2.0 SITE CHARACTERISTICS

This chapter of the North Anna 3 combined license (COL) Final Safety Analysis Report (FSAR) addresses the geological, seismological, hydrological, and meteorological characteristics of the site and vicinity, in conjunction with present and projected population distributions and land use and site activities and controls

Section 2.0 of the North Anna 3 COL FSAR incorporates by reference Section 2.0 of the Economic Simplified Boiling-Water Reactor (ESBWR) design certification document (DCD), Revision 5. In addition, FSAR Section 2.0 incorporates by reference ESP-003 for the North Anna ESP Site, issued pursuant to 10 CFR 52.24, and documents related thereto (e.g., North Anna ESP Application Site Safety Analysis Report (SSAR), Revision 9).

Figure 2.5.4-7 Plans for Excavation (FSAR Figure 2.5-214)

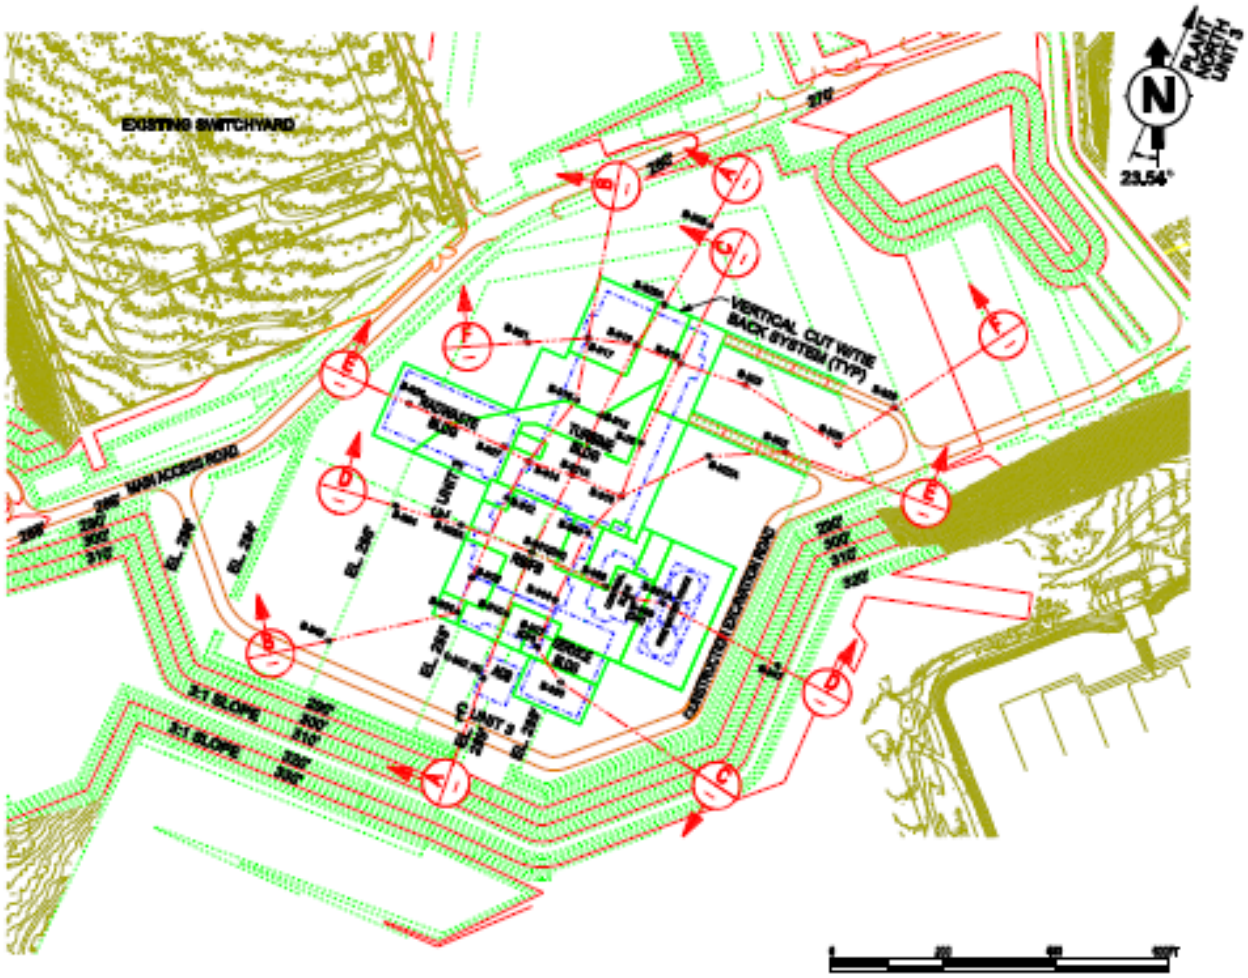
The staff reviewed the extent of seismic Category I excavations, fills, and slopes, especially FSAR Figure 2.5-214 (Figure 2.5.4-7 of this SER), which shows the planned excavations relative to power block foundations. The staff compared the excavation plans with the requirements of 10 CFR 100.23 and concluded that the description of the extent of the excavations, fills, and slopes is acceptable. The staff also concluded that this information satisfies Permit Condition 3.E(6), which requires the applicant to provide information on geologic mapping of future excavations. The staff then reviewed the excavation methods and stability for the Unit 3 site, which included a review of the soil excavation methods as well as the blasting techniques used for rock excavations against the requirements of 10 CFR 100.23 and guidance contained in RG 1.132. The staff concluded that the methods of excavation and stability are acceptable because the applicant has described plans to follow OSHA regulations when excavating into soil and will use conventional and widely accepted industry equipment to accomplish the excavation. Furthermore, the staff concluded that the applicant's plans to monitor blasting, including the use of controlled blasting techniques as part of the excavation into rock, are acceptable to reduce vibrations at the site during the period of excavation.

Figure 2.5.5-2 Output of Slope Stability Analysis Using the Bishop Method

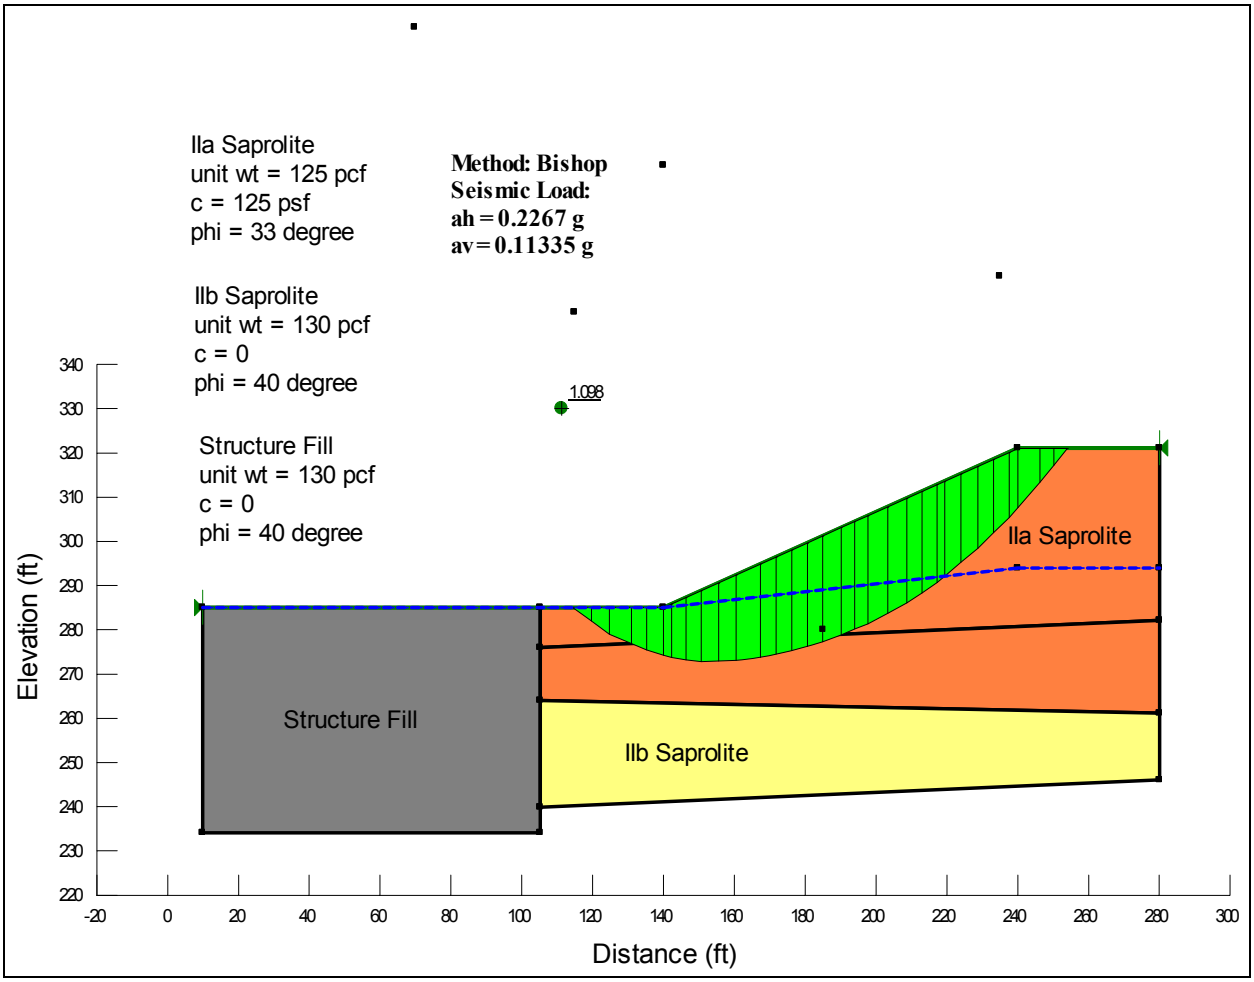
The staff considered the applicant's statement that all slope stability analysis methods have their own advantages and limitations, and the Bishop method may or may not give the most conservative results. Accordingly, the staff conducted an independent confirmatory analysis for a selected slope using the information in Figure 2.5-266 of the FSAR. The staff obtained the FS using GeoSlope—the same computer software used by the applicant. The calculated FS values are listed below, and the results from one of the analyses are illustrated in Figure 2.5.5-2.

The staff also reviewed the assumptions used for the seismic stability analysis of slopes in the Unit 3 area. Some of the assumptions stated by the applicant include (1) no liquefaction was considered in the analysis, (2) the use of average peak acceleration as opposed to peak accelerations at the surface, and (3) the consideration of reduced accelerations. These assumptions are contrary to the guidance in RG 1.206, which states that the applicant should demonstrate the reliable performance of slopes during all conditions during the life of the plant. In **RAI 2.5.5-3**, the staff asked the applicant to describe the impact of the possible maximum

The applicant's response stated that the possible maximum dynamic settlement of 41 mm (1.6 in.), corresponding to a reduction in slope height of between 0.38 and 0.31 percent, would not impact the slope stability. The applicant also stated that the reason the slope failure during a seismic event is not a slip failure is because during a seismic event, the slope loses strength due to liquefaction. Although the applicant noted that liquefaction would weaken the slope, a large portion of the slope is not prone to liquefaction because 8.5 m (28 ft) of the slope is above the groundwater table. In addition, the applicant concluded that, based on the low- and high-frequency seismic characteristics, the chances of any liquefaction occurring in the Zone IIA saprolitic soils are very low. Due to the low chance of liquefaction, the applicant concluded that the strength loss of the slope from liquefaction was remote. Therefore, the slopes will remain stable during the design earthquake at the Unit 3 site.
